# Access Compliance Report

## Public Rights-of-Way

### (Curb Ramps)

Intersection ID: 20640	Main Street: S_TRYON_ST	Cross Street: YAGER_CREEK_DR	Location: W
ADA ID: 518C3741F29E	Ramp Type: Perp	Initial Pass/Fail: Pass	Overall Compliance: No
Codes/Mitigation Info/Possible Solution		Field Measurements/Component Compliance	
Severity Score: 27.75

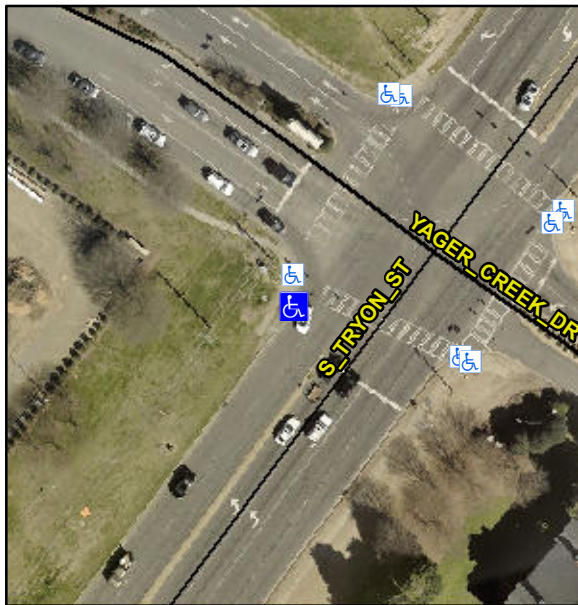
**Not Found, R304.5.3, R304.2.1,  
R304.2.2-Perp, R304.3.2-Para, R305,  
R207.1, R302.7.2**

Compliance	Description	Data	Compliance	Description	Data
N/A	Ramp Length (in)	102.0	Yes	Ramp Slope (%)	6.2
Yes	Ramp Width (in)	48.0	No	Ramp XSlope (%)	3.5
N/A	Flare Type LT	Sloped	N/A	Flare Type RT	N/A
N/A	Flare Slope LT (%)	9.6	Yes	Flare Slope RT (%)	6.3
N/A	Flare Traversable LT?	Yes	N/A	Flare Traversable RT?	Yes
No	Landing Length (in)	N/A	No	DWS Provided?	No
No	Landing Width (in)	N/A	N/A	DWS Contrast?	No
No	Landing Slope (%)	N/A	N/A	DWS Length (in)	N/A
No	Landing X Slope (%)	N/A	N/A	DWS Full Width?	No
N/A	Landing Curb? (Y/N)	No	N/A	DWS Offset (in)	N/A
N/A	Shared Landing?	No			
Yes	Gutter Ponding?	No	Yes	Gutter Slope (%)	0.6
No	Gutter Lip Ht (in)	0.5	Yes	Gutter X Slope (%)	2.8
N/A	Painted X Walk1?	Yes	N/A	Painted X Walk2?	N/A
	X Walk 1 Direction	To SE		X Walk 2 Direction	N/A
N/A	X Walk 1 Width (in)	110.0	N/A	X Walk 2 Width (in)	N/A
	X Walk 1 Slope (%)	1.9		X Walk 2 Slope (%)	N/A
	X Walk 1 X Slope (%)	2.8		X Walk 2 X Slope (%)	N/A

No	Ramp inside XWalk1?	No	N/A	Ramp inside XWalk2?	N/A
	Road Slope (%)	N/A	N/A	Clear Space?	Yes
	Road X Slope (%)	N/A	N/A	Clear Space to XWalk (in)	N/A
Yes	Any Obstructions?	No	Yes	Storm Grate/Utility Hazard?	No
	Obstruction Type			Storm Grate/Utility Type	
		N/A			N/A
			Yes	Surface Condition? (G/P)	Good

**Remove & Replace Entire Ramp.  
Restripe Crosswalk.**
